**RE: Development Application No. 15.1/2014 - Residential flat building  
184 – 192 Restwell Road, Prairiewood**

Following the assessment undertaken by SJB Planning of the amended application, we note the comments raised in their letter dated 19 November 2014 and provide the following responses in no particular order.

**Figure One:** Prairiewood DCP Extract showing Service Lane

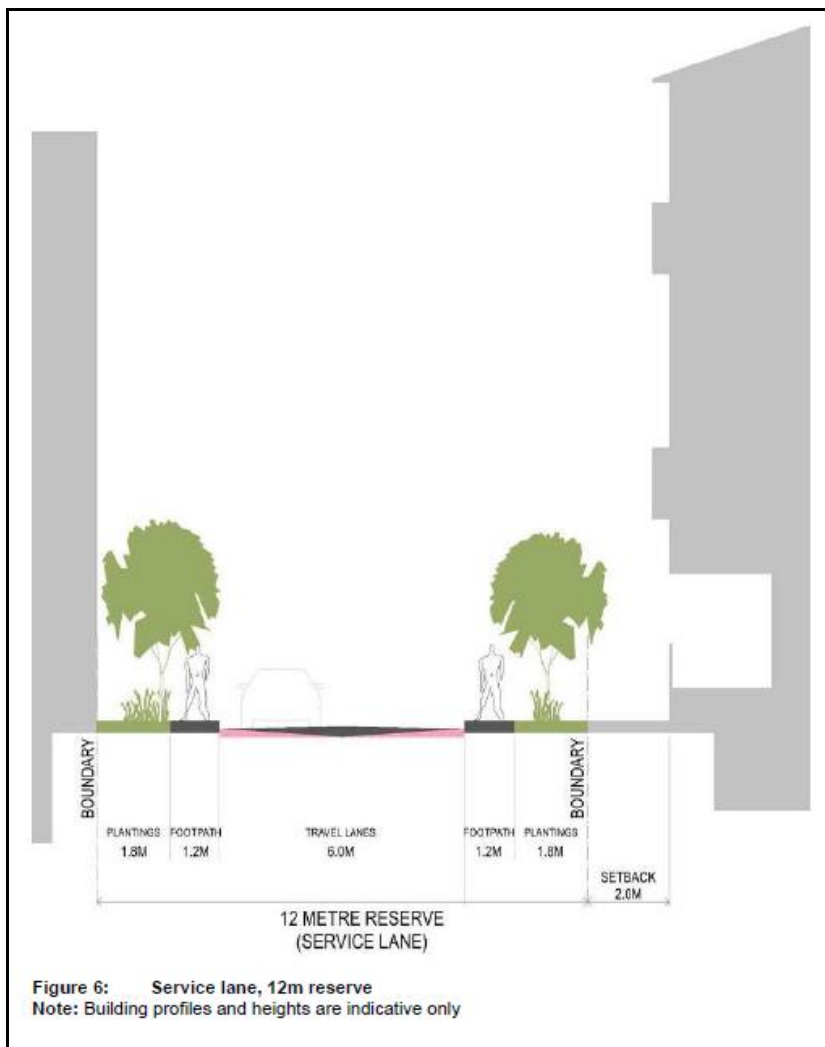
In terms of the east-west service road, the SJB letter states that the road is to be at least 6.5m in width. We respectfully submit that SJB Planning has misunderstood the DCP as our width is compliant with that prescribed by the DCP. This is illustrated in Figure 6 on page 13 of the Prairiewood Town Centre Development Control Plan, whereby an extract is provided as Figure One on the following page.

On this basis, we respectfully submit that our development is compliant with this aspect of the DCP.

**Figure Two:** Plan showing one way traffic flow (anti-clockwise)

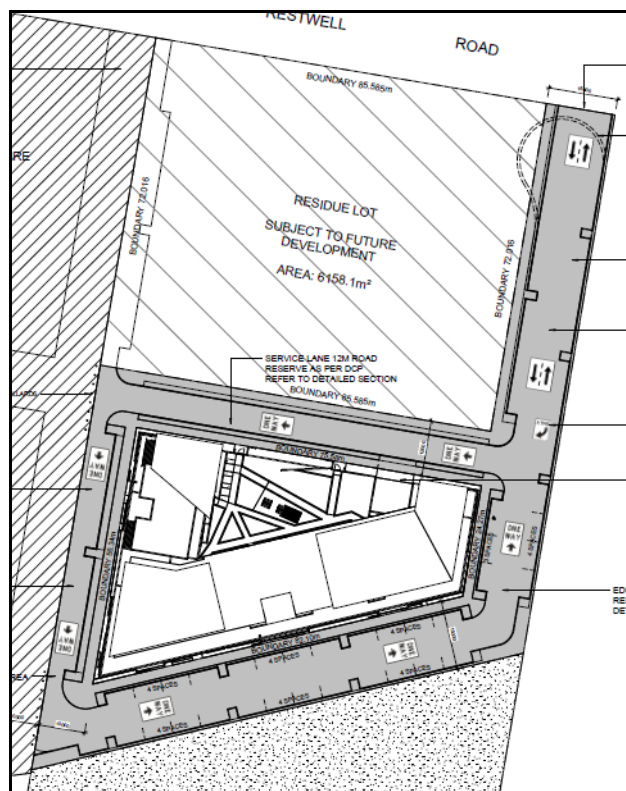
2. In addition to the planter boxes, the installation of a temporary turning head on the residue allotment to the north. Again referring to Sheet 04, we have indicatively shown the location of this turning area which will allow vehicles heading in a westward direction along the east – west service lane to turn around. Noting that the remainder of the north – south collector road will be closed off.
3. One way traffic circulation (preferred option). Referring to sheet S04.1 and Figure Two on the following page, this option allows for the dedication of the roads with appropriate signposting directing and controlling traffic in and around the development as a one way anti-clockwise direction. This will allow vehicles to enter and leave the basement area in a 'left in' and 'left out' arrangement.

The benefit of this option is that the north – south collector road will not be closed off, therefore allowing the parking bays along this road to be accessed for persons visiting the precinct.

**Figure Four:** Plan showing roof elements (blue) which breach the height limit

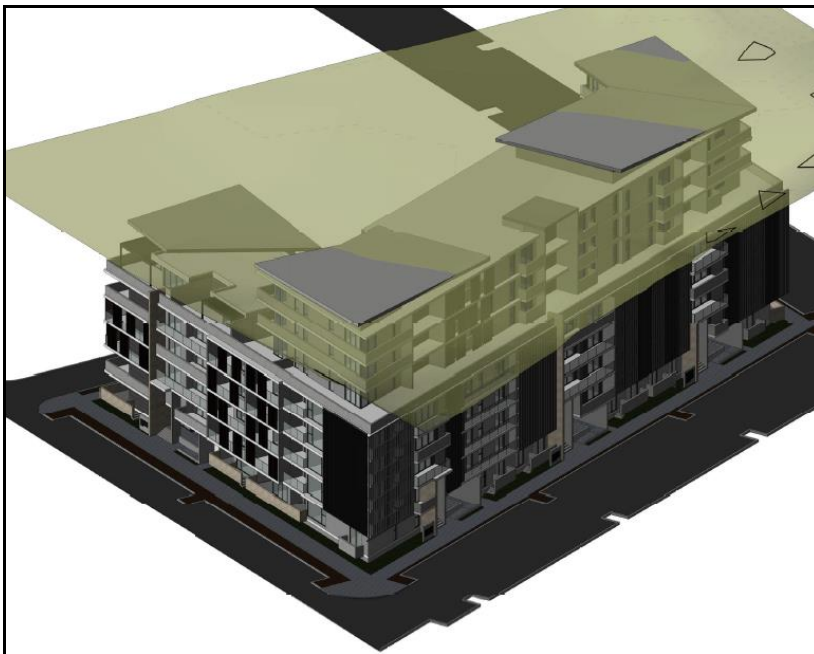
On this basis it is submitted that the roof form provides for an architectural roof feature which is a decorative element on the upmost portion of the building, commensurate with the proposed development. This decorative portion results in a maximum breach of 1.6m. It is also our submission that the roofs also need to be articulated. (Refer to Figure Three below)

To further highlight the extent of the non-compliance, Pagano Architects has prepared a separate image (See Figure 4) which shows the extent of the breach (by way of veil where the 26m height limit would be), clearly demonstrating that it is in fact a roof feature in three separate areas, as opposed to habitable floor space.

Based on the above, we feel that the minor breach to the height limit forms part of an integral architectural roof feature to which Clause 5.6 allows the building height to be exceeded, subject to development consent from Council.
